### VALUE ENGINEERING CHANGE PROPOSAL MISSOURI DEPARTMENT OF TRANSPORTATION

Contract ID 091023-503

Job No. 15B08010

VECP# 10-53 (to be completed by C.O.)

# Crossover on Divided Highway

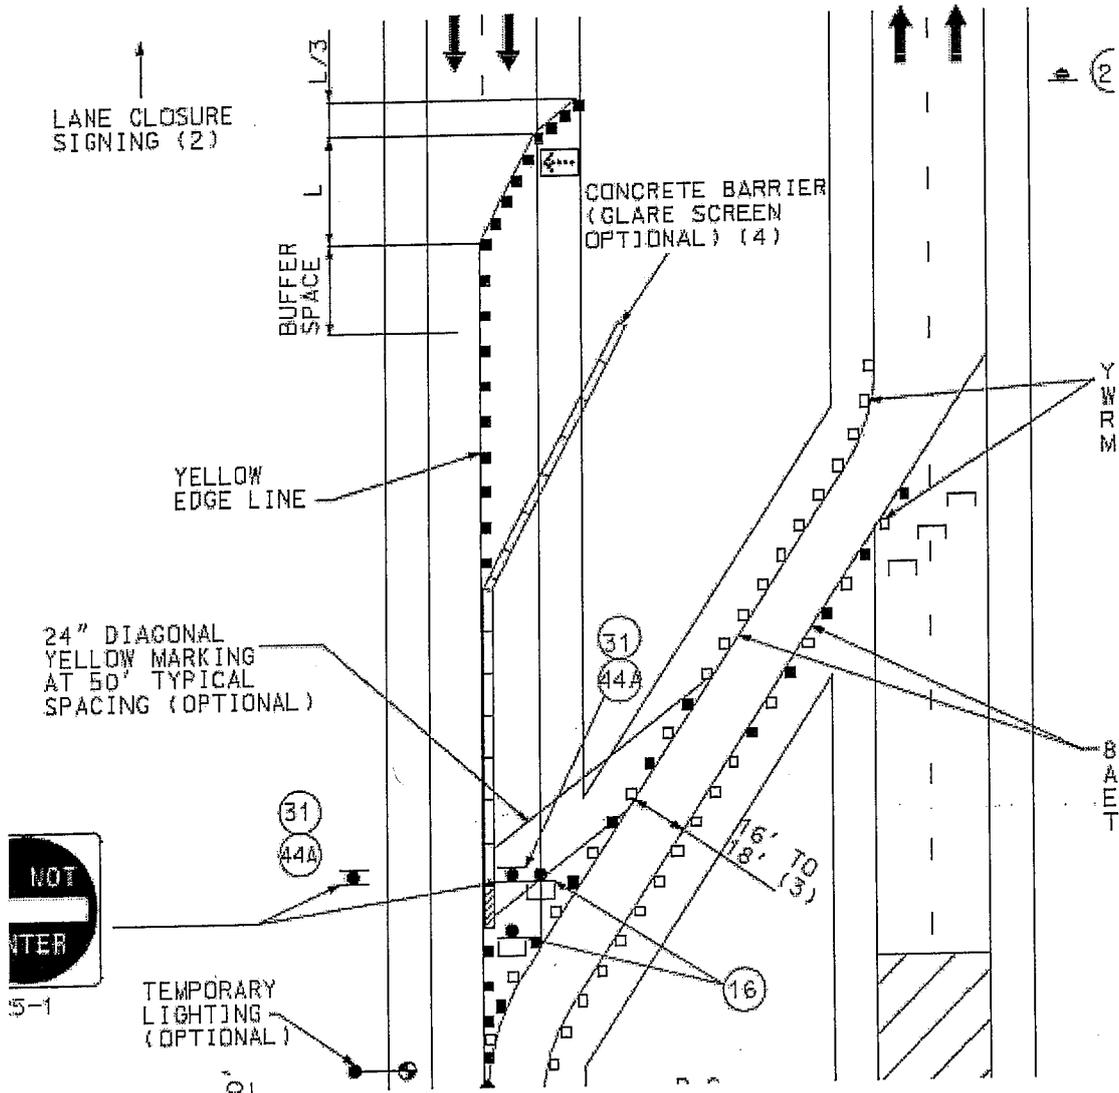
The EPG does not specify the length of barrier along the crossover but does specify that it needs an additional standard lane taper of 128'. With Lehman's proposal, this would leave 247' barrier tangent to traffic (total barrier of 375'). This should be sufficient. The channelizer taper lengths, buffer area lengths and temporary striping should not change though.

# Crossover on Divided Highway

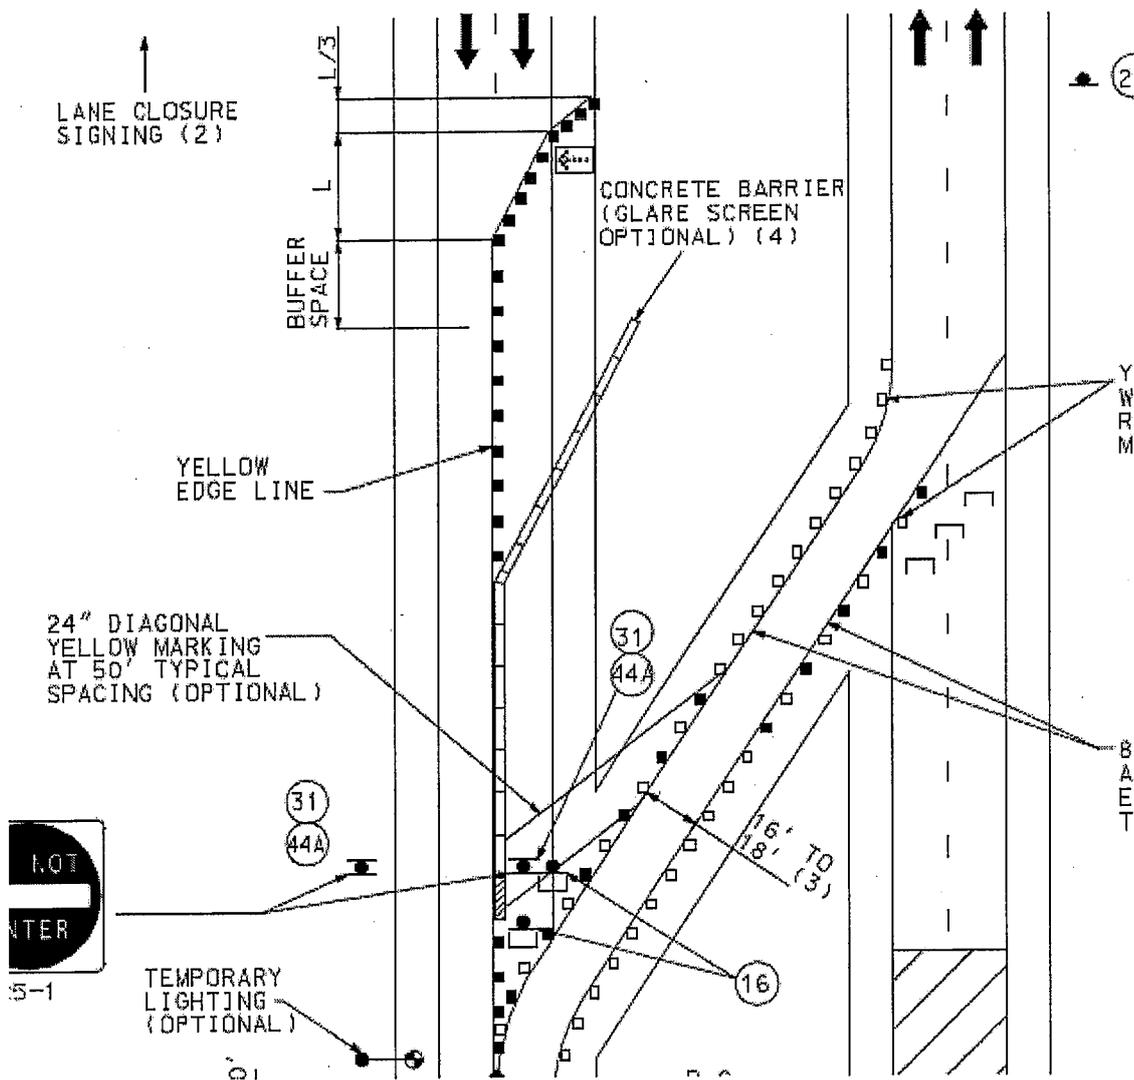
Patty: Troy and I discussed the below VE proposal and we do not recommend the reduction of barrier length. This barrier is used to prevent any head to head accidents that could occur between the opposing traffic. As with any work zone we should allow the traveling public enough space to slow down or stop before hitting any obstacle, per example, barrier. The actual length of the tangent barrier should be the length of the buffer space. I reviewed the EPG, MUTCD and drawings and the below drawing is the only guidance.

The EPG does not specify the length of barrier along the crossover but does specify that it needs an additional standard lane taper of 128'. With Lehman's proposal, this would leave 247' barrier tangent to traffic (total barrier of 375'). This should be sufficient. The channelizer taper lengths, buffer area lengths and temporary striping should not change though.

*Further discussion between Brian A Williams and central office traffic confirmed their position to keep length of temp cone barrier per plan.*
